SUBMITTAL OF DANGEROUS WASTE PERMIT PACKAGE PTF-009, REVISION 2, FOR THE PRETREATMENT FACILITY

Permit Package PTF-009, Revision 2, Supplemental
Permit Package for FRP-VSL-00002A, FRP-VSL-00002B,
FRP-VSL-00002C, and FRP-VSL-00002D Vessel Alterations

Supplemental Permit Package PTF-009, Rev. 2 Description
Vessel Alterations to FRP-VSL-00002A/B/C/D

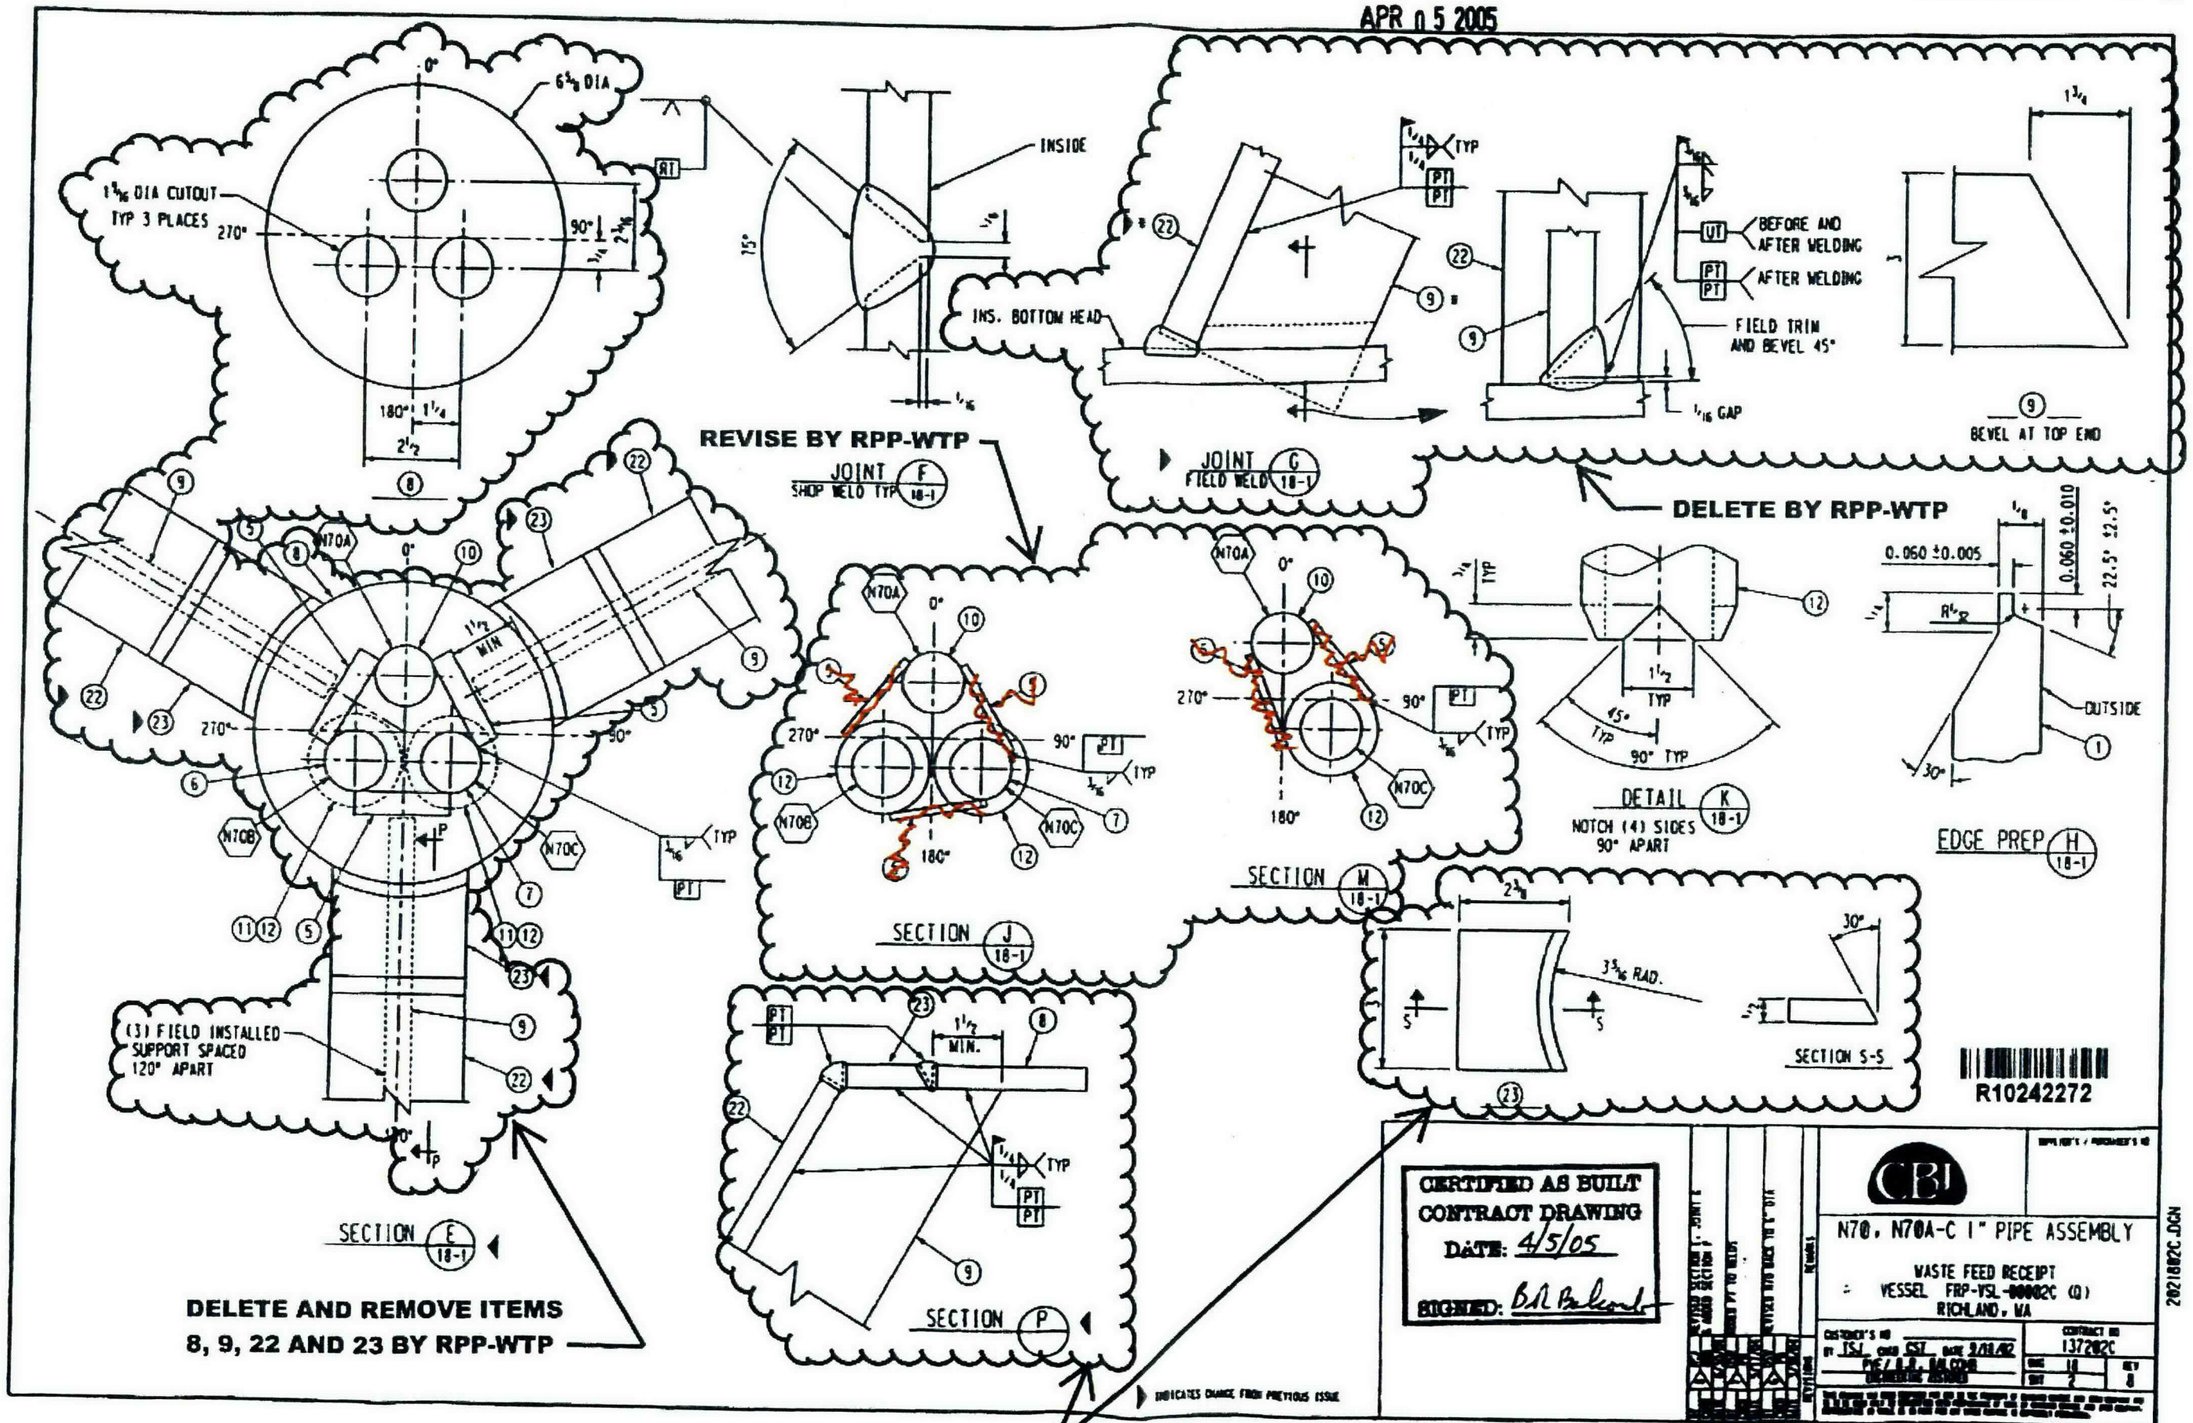
DELETE BY RPP-WTP

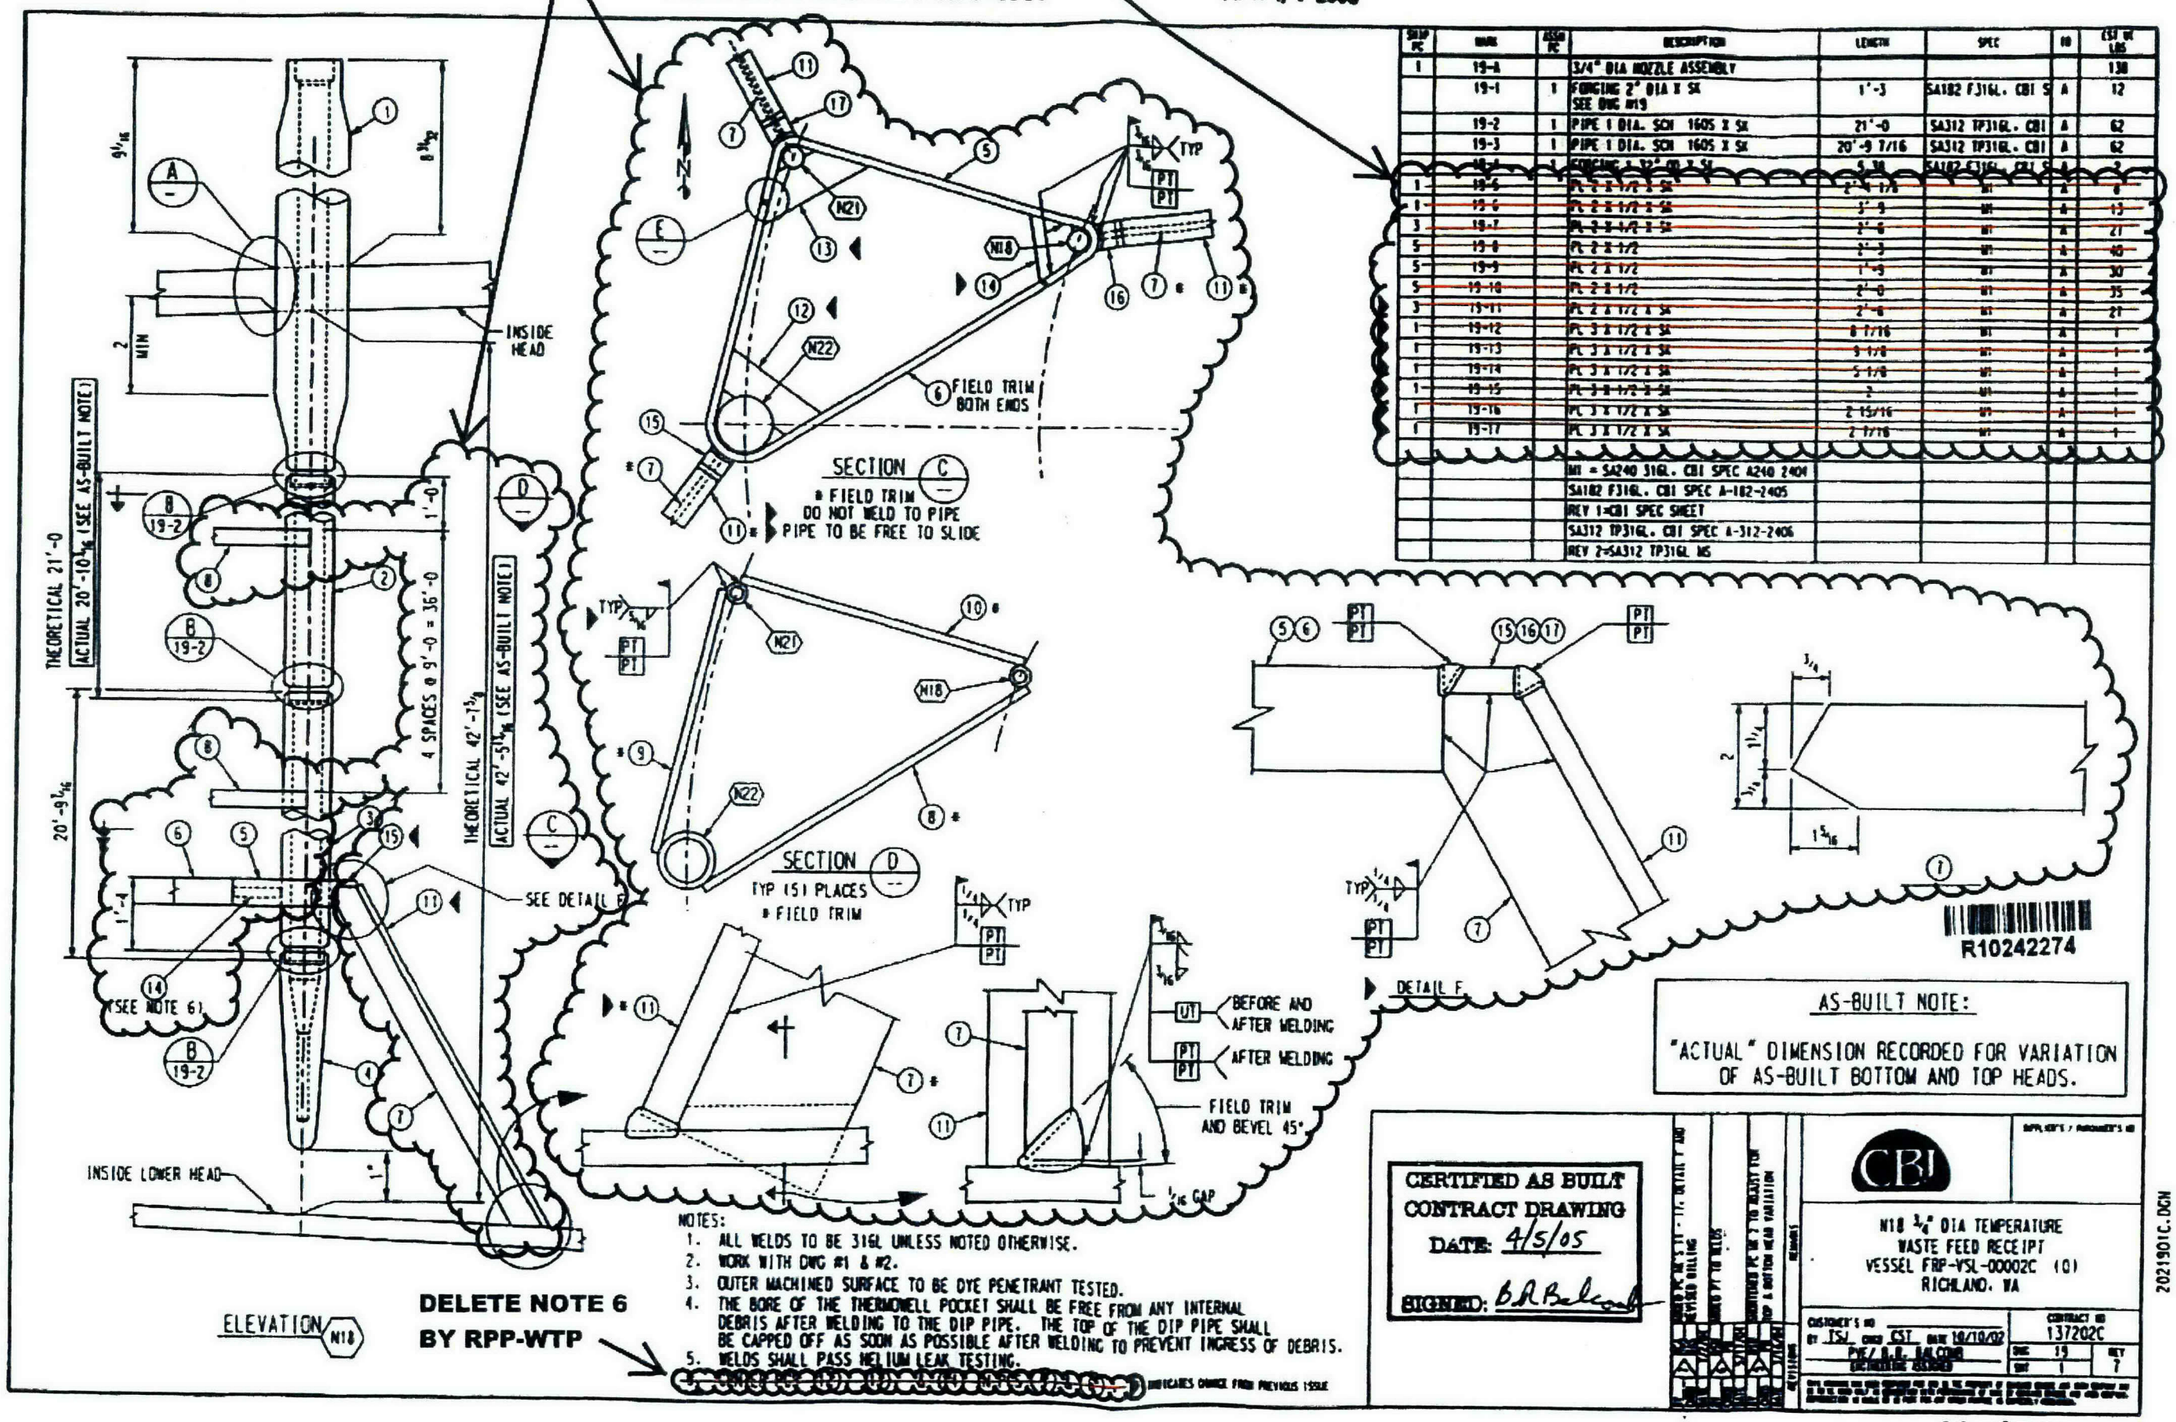
DELETE AND REPLACE WITH NEW SUPPORTS BY RPP-WTP

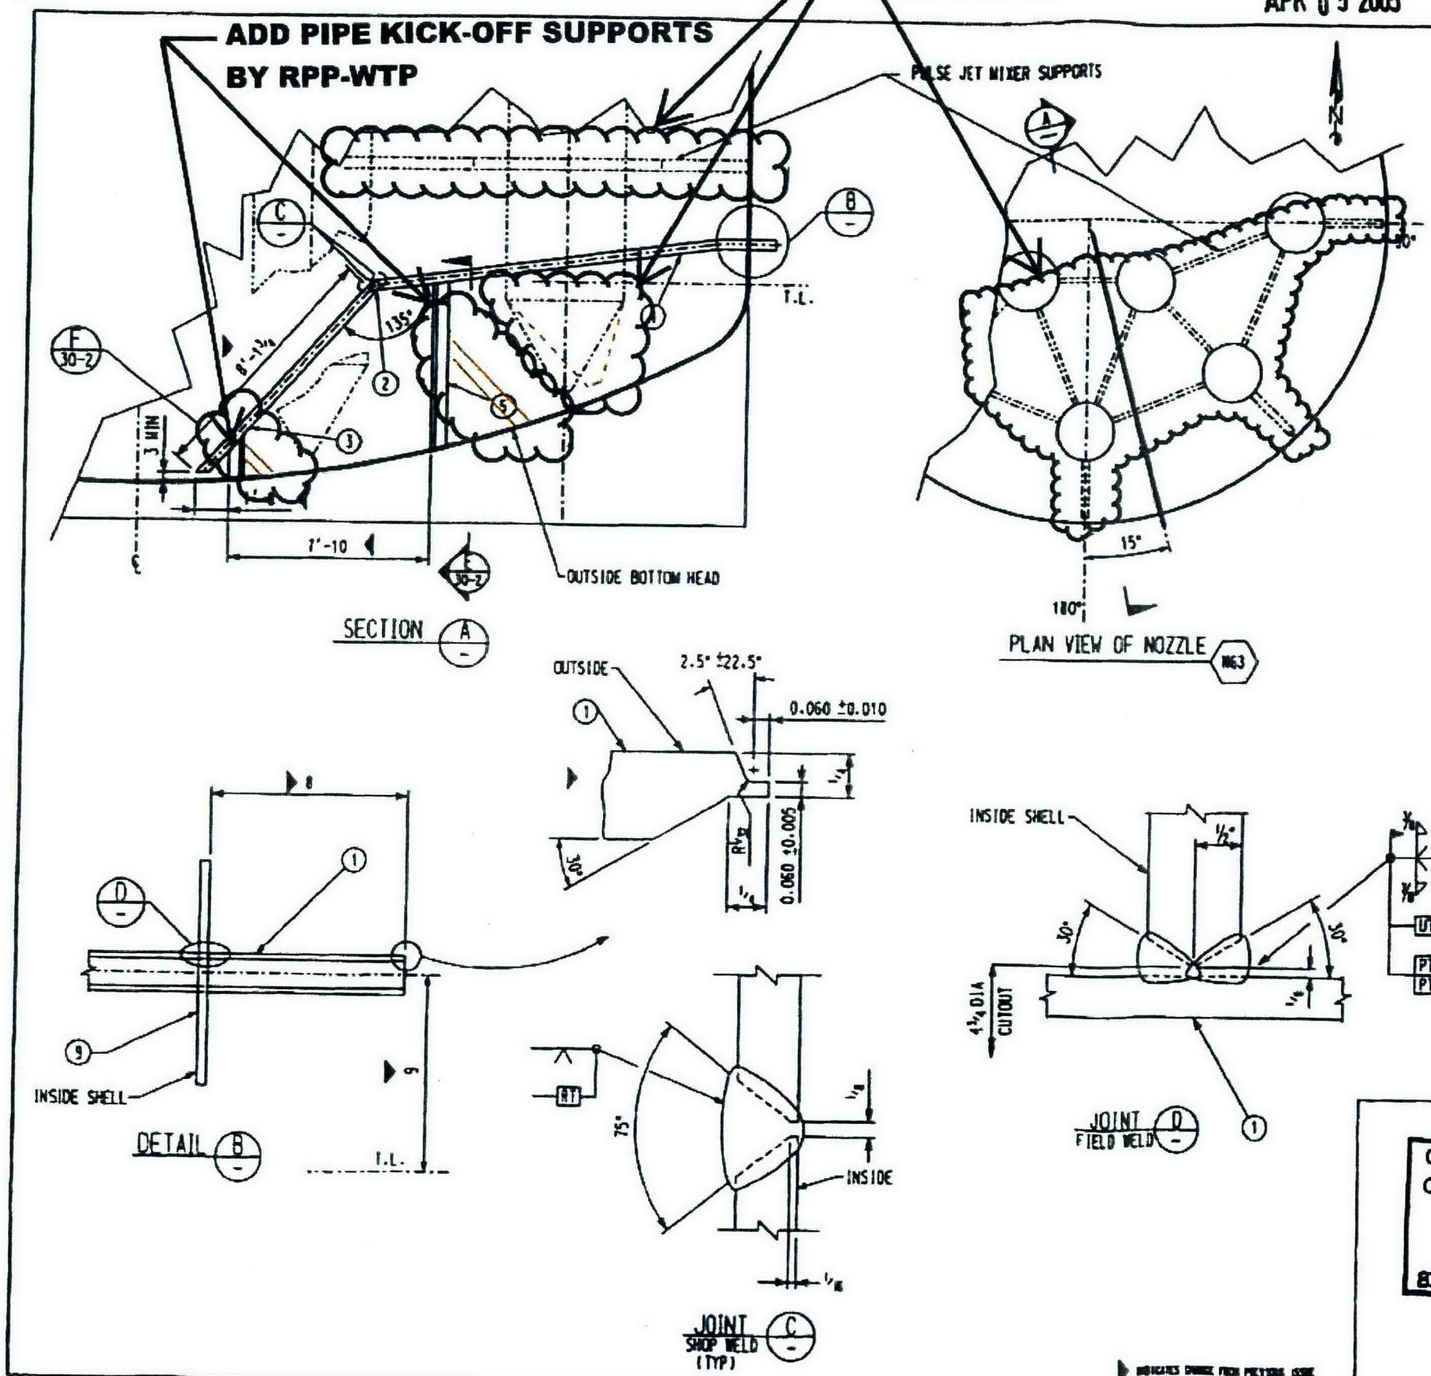
ADD PIPE KICK-OFF SUPPORTS BY RPP-WTP

WASH RING PLAN VIEW
N56-N62

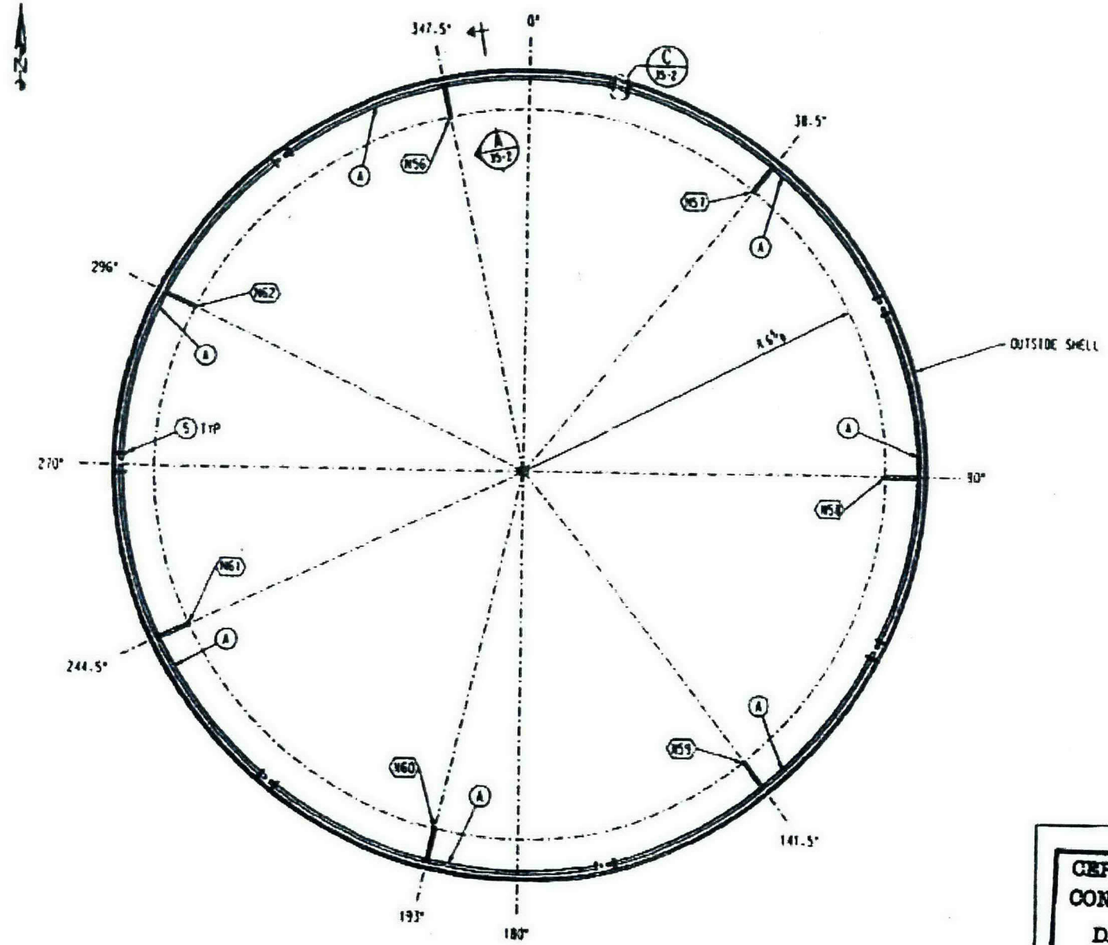
REVISE BY RPP-WTP ON HOLD → 160S

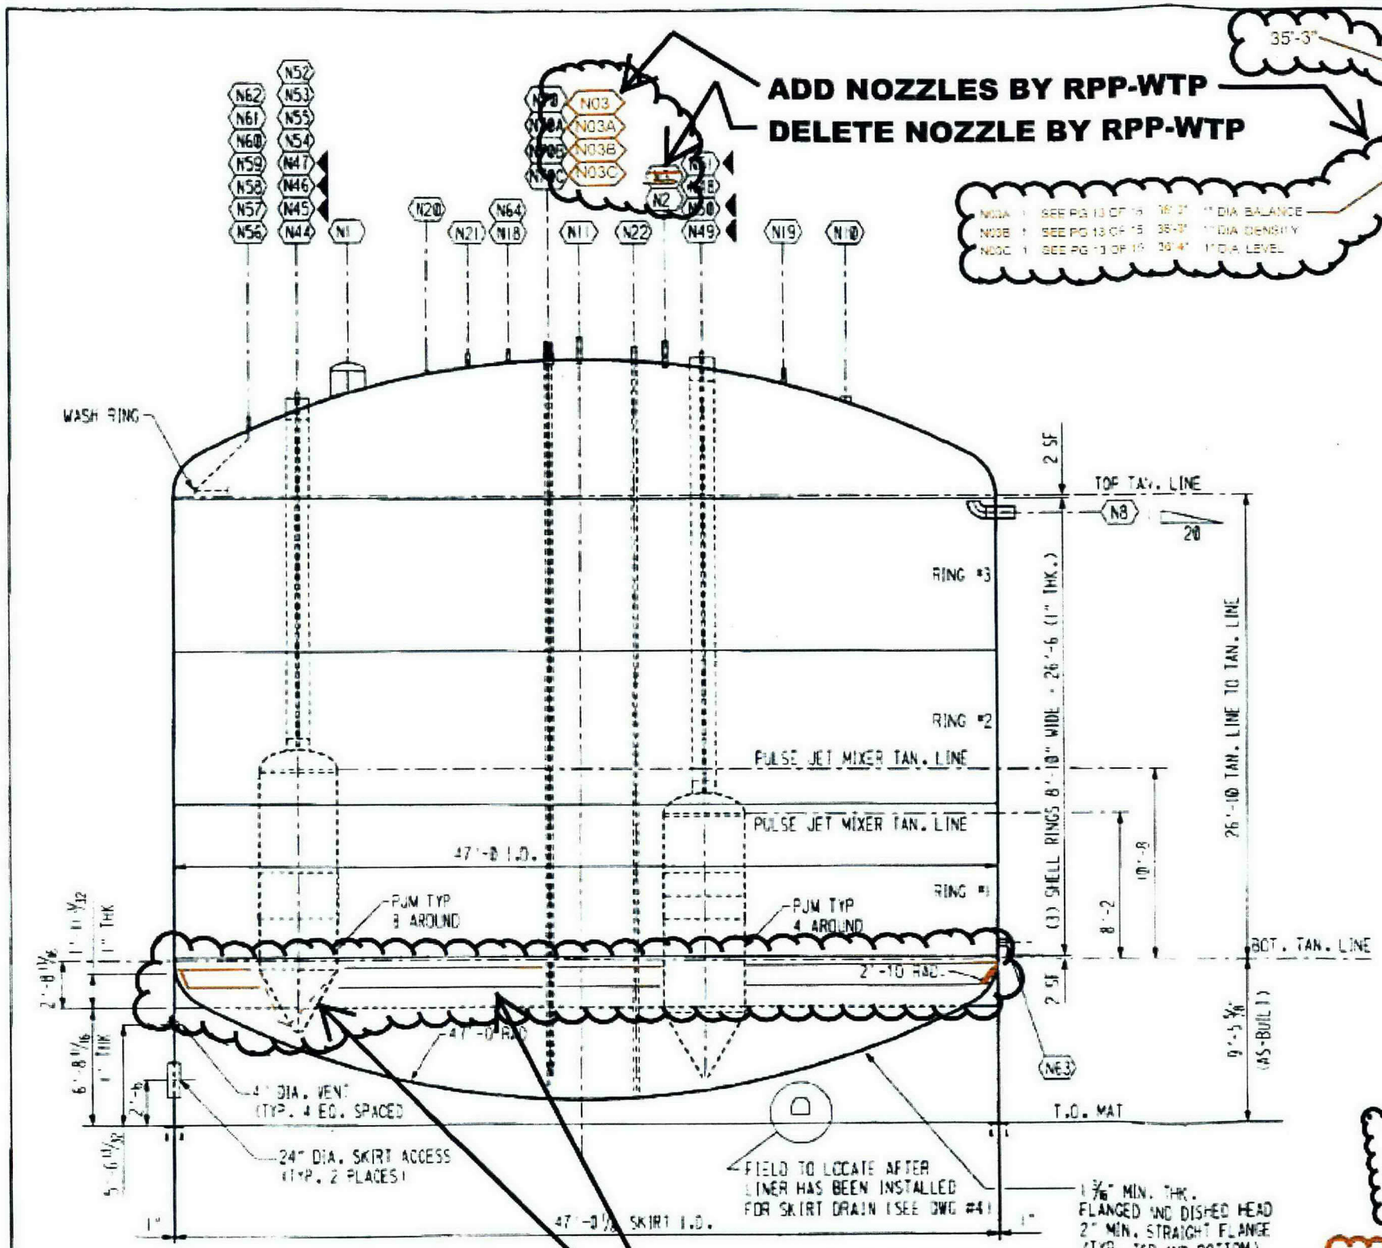
DELETE NOZZLE BY RPP-WTP
